WARD STREET
WASHINGTON STREET TO ZION STREET
CURB PROFILE
HOR. SCALE 1"=20'
VER SCALE 1"=2'
Stations Measured on Center Line & on Slope
Day BooK No. 08704 NotebooK 759

City of Hartford
Department of Engineering
January 1945

THIS PROFILE TO BE USED WHEN "WARD ST." is PAVED AND WIDENED TO A 36' Roadway

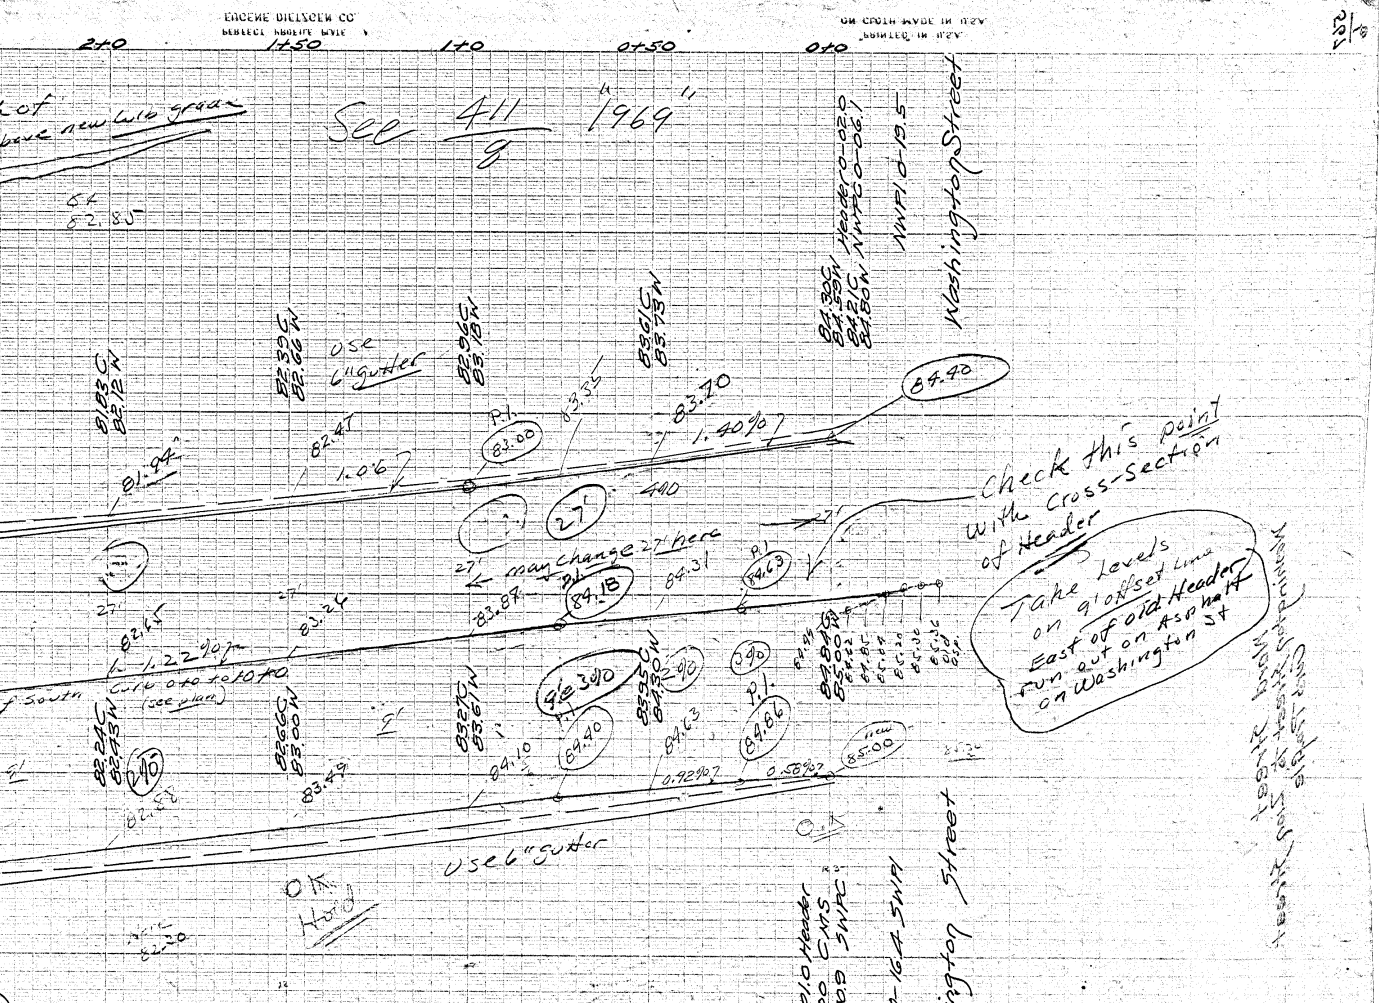
Check this point with Cross-Section of Header

Take Levels on 9' offset Line East of old Header run out on Asphalt on Washington St
